**Consolidated Statements from Opponents of
the 2nd Story Project at 985 Channing Avenue, Palo Alto**

The plans were received on 08/24/20 for review by Planning Staff. Based on the initial feedback from staff, the application **cannot be deemed complete at this time**. A revised set of plans incorporating the following information and requirements must be submitted for review:

DUNLAP RESIDENCE

985 CHANNING AVENUE
PALO ALTO, CA 94301

EXISTING & PROPOSED SITE PLANS

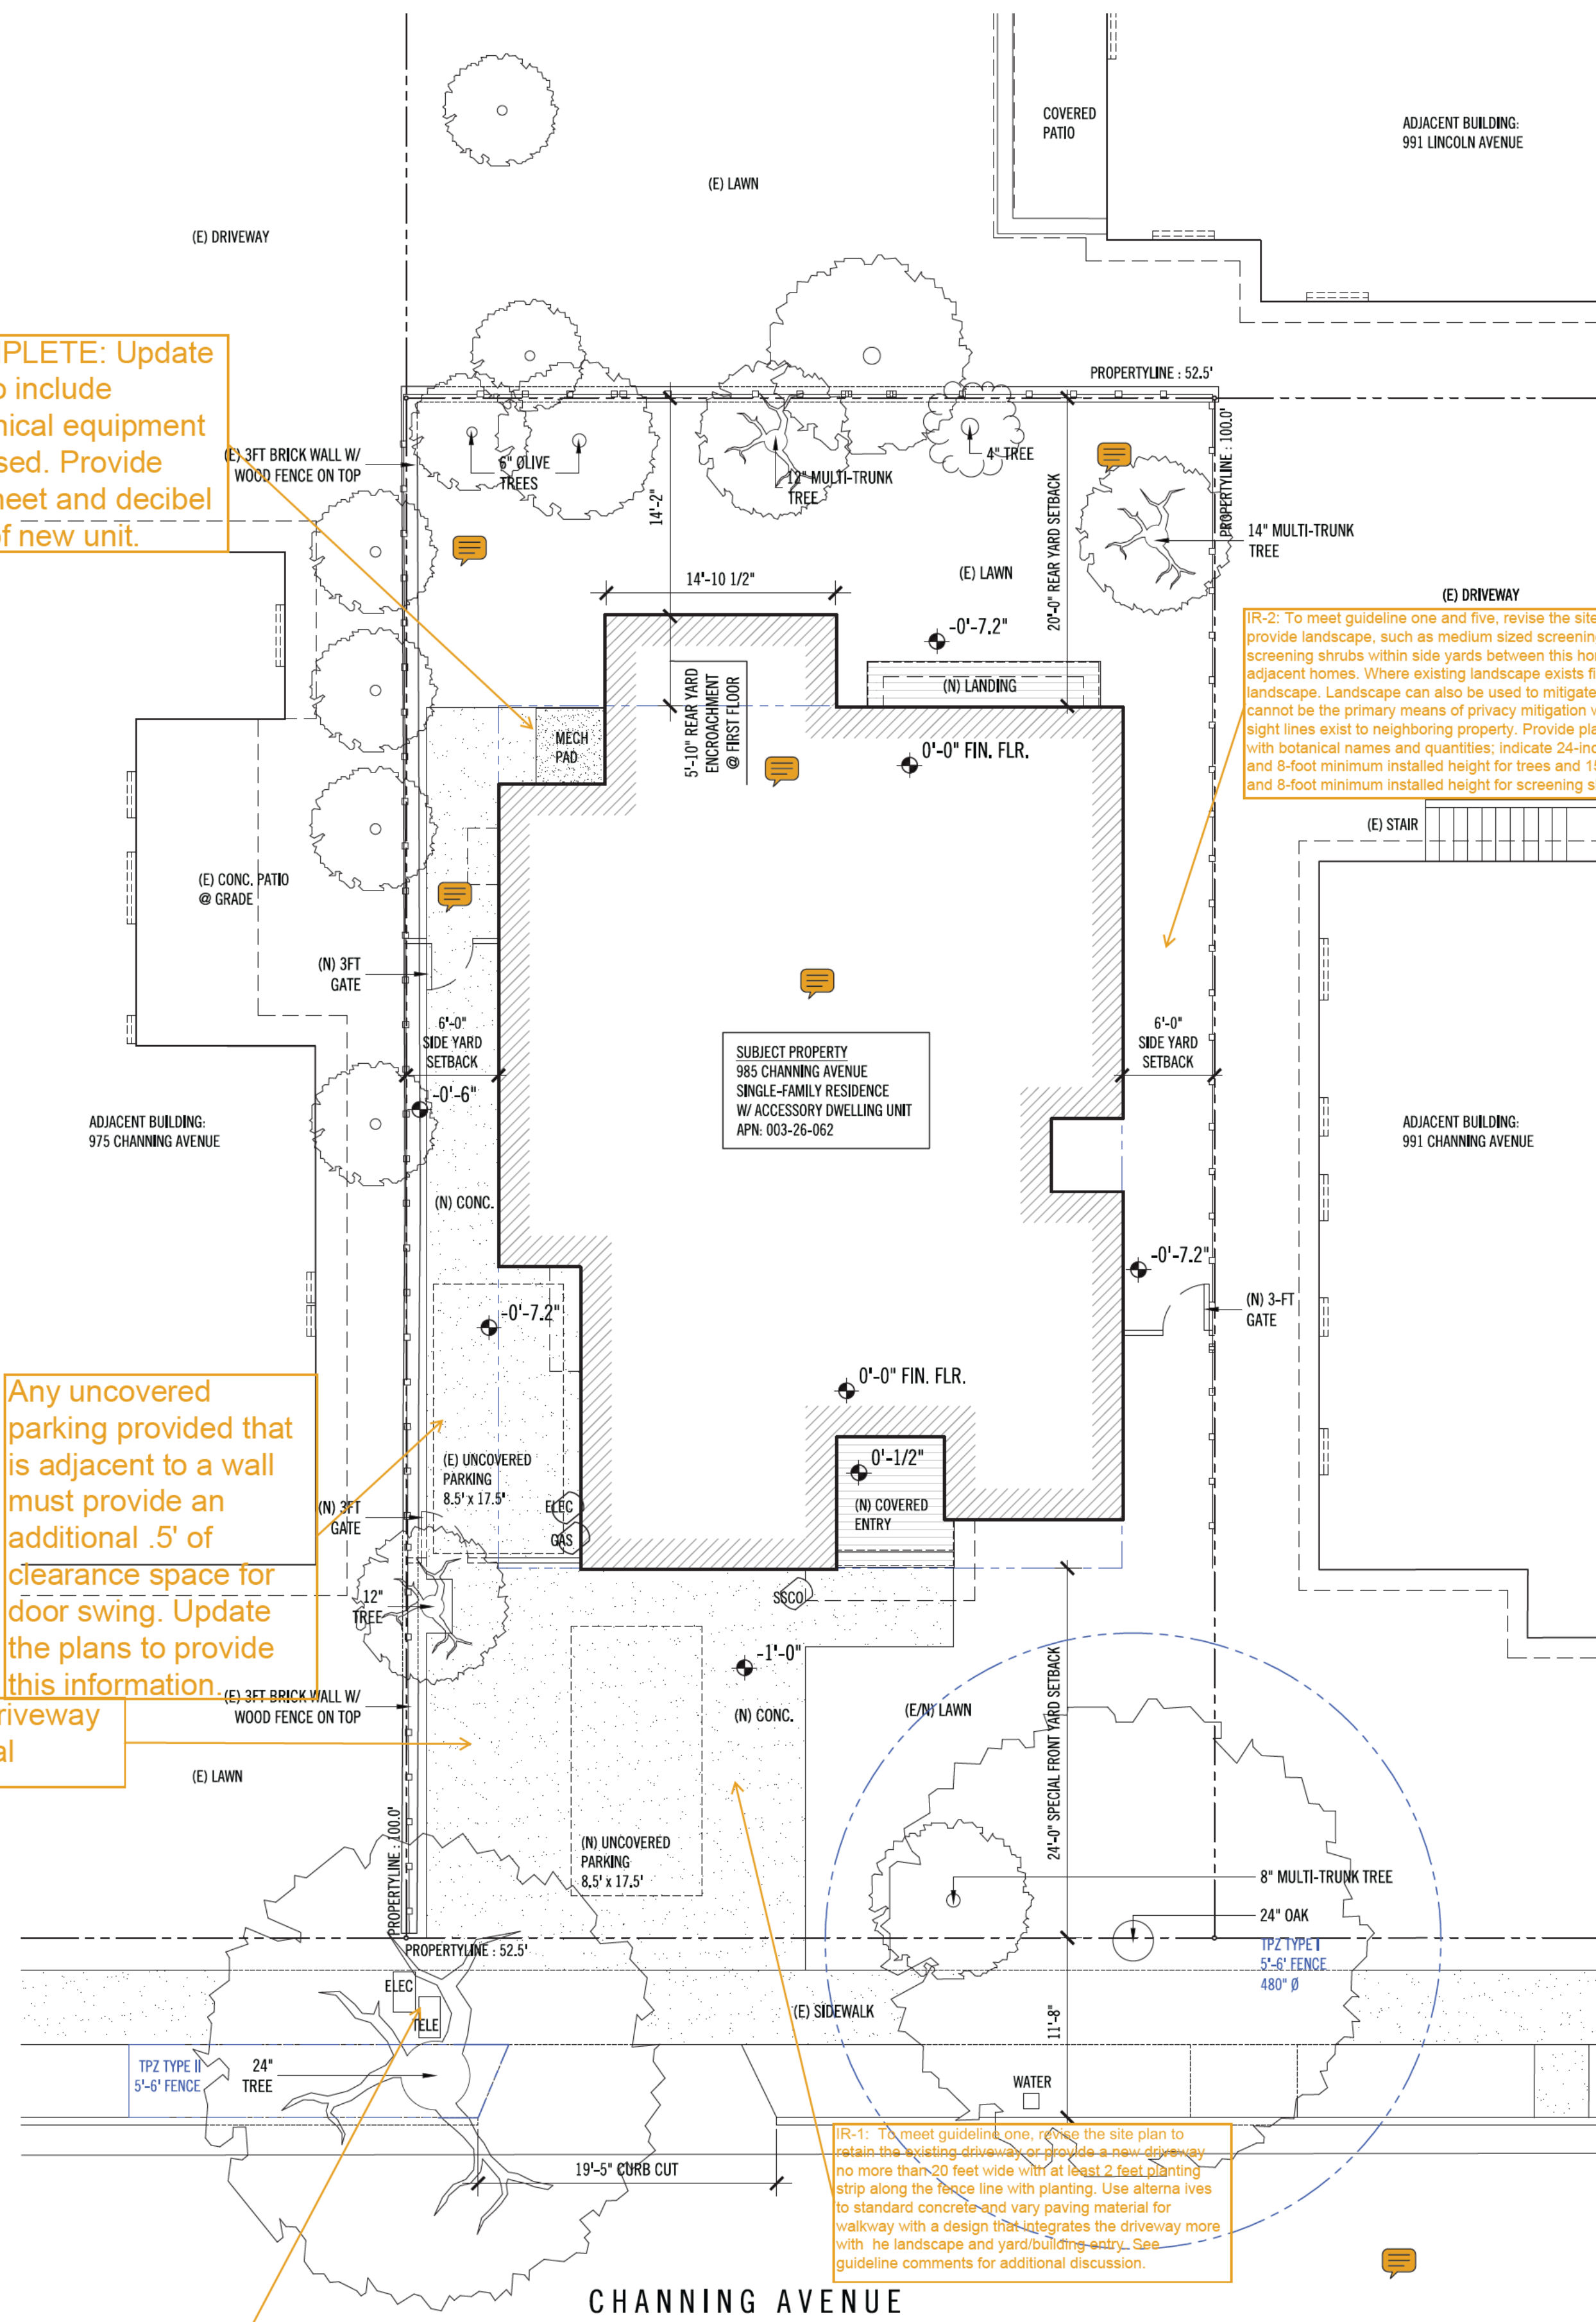
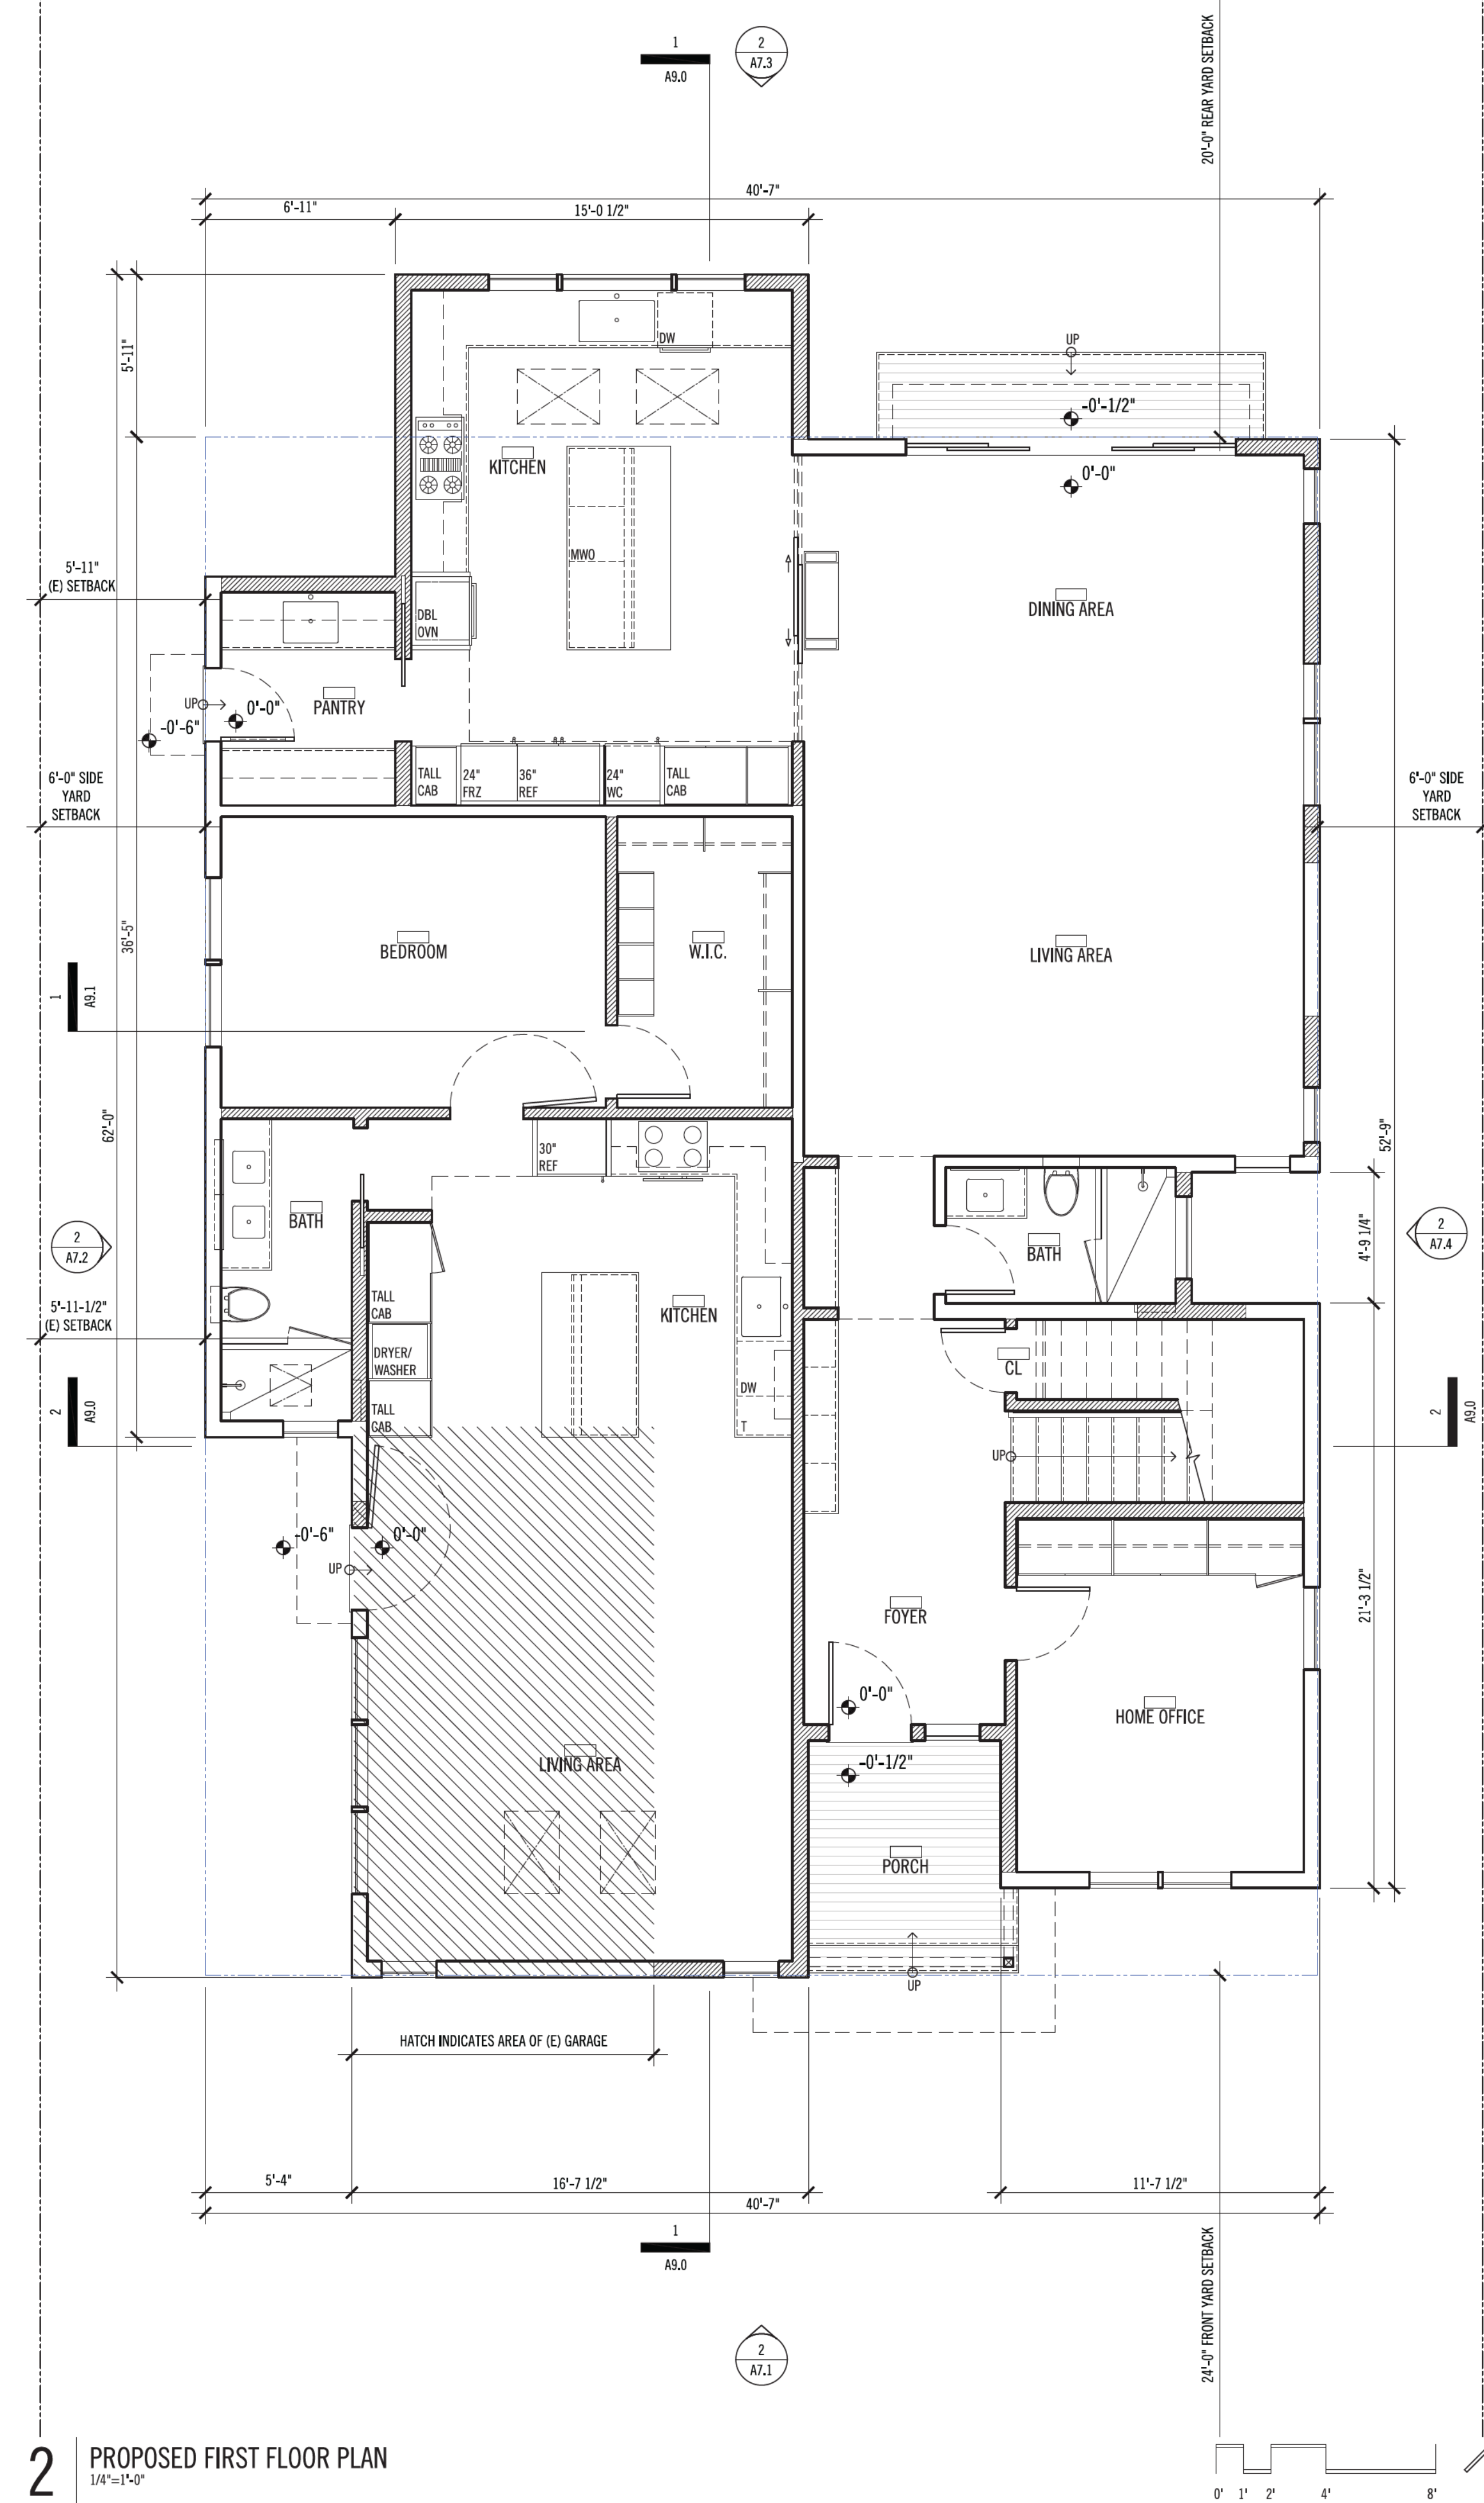
INCOMPLETE: Update plans to include mechanical equipment to be used. Provide spec sheet and decibel rating of new unit.

Any uncovered parking provided that is adjacent to a wall must provide an additional .5' of clearance space for door swing. Update the plans to provide this information.

Note driveway material

Update to show

IR-2: To meet guideline one and five, revise the site plan to provide landscape, such as medium sized screening trees or tall screening shrubs within side yards between this home and adjacent homes. Where existing landscape exists fill gaps in the landscape. Landscape can also be used to mitigate privacy, but it cannot be the primary means of privacy mitigation where direct sight lines exist to neighboring property. Provide plant choices with botanical names and quantities; indicate 24-inch box size and 8-foot minimum installed height for trees and 15-gallon size and 8-foot minimum installed height for screening shrubs.

IR-1: To meet guideline one, revise the site plan to retain the existing driveway or provide a new driveway no more than 20 feet wide with at least 2 feet planting strip along the fence line with planting. Use alternate to standard concrete and vary paving material for walkway with a design that integrates the driveway more with the landscape and yard/building entry. See guideline comments for additional discussion.
